FORM APPROVED
OMB NO. 1004-0135
Expires: July 31, 2010**SUNDRY NOTICES AND REPORTS ON WELLS**
Do not use this form for proposals to drill or to re-enter an abandoned well. Use form 3160-3 (APD) for such proposals.**SUBMIT IN TRIPLICATE - Other instructions on reverse side.**

APACHE CORP REQUEST TO CHANGE TVD & MD FOR THE NFE FEDERAL #53H
FROM: TVD: 4875' MD: 10550'
TO: TVD: 5003' MD: 10578' Landing point: 4805'

Project: Eddy County, NM (NAD27 NME)
Site: NFE Federal
Well: #53H
Wellbore: WB1
Design: Plan #3 01-30-15
Rig: TBD

Plan: Plan #3 01-30-15

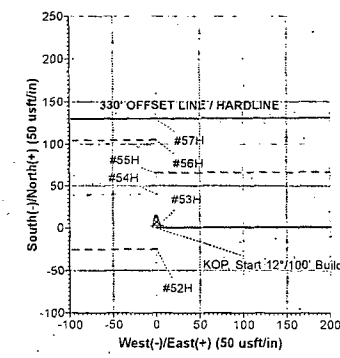
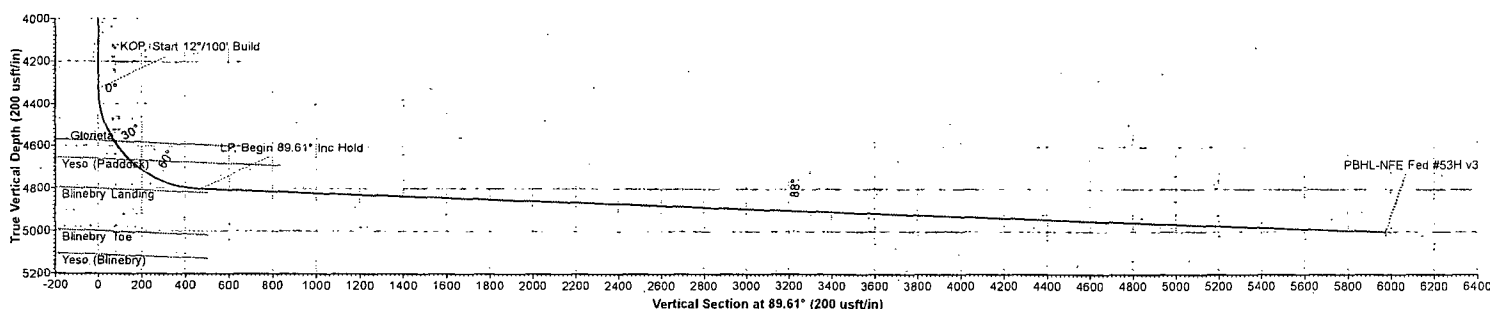
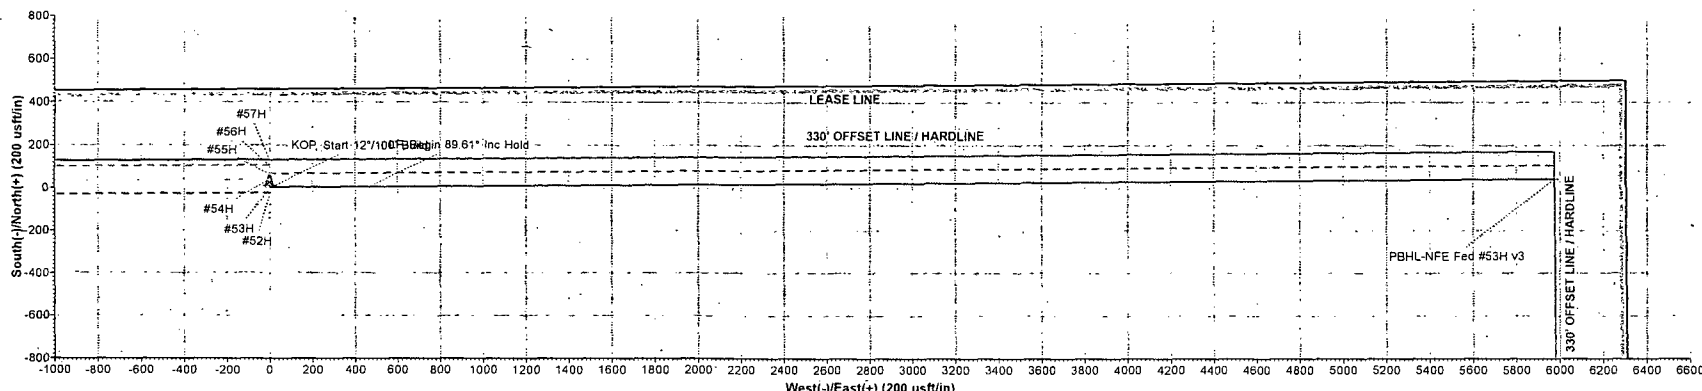
NEW DIRECTIONAL PLAN ATTACHED. NO OTHER CHANGE FROM ORIGINAL DRILLING PLAN.
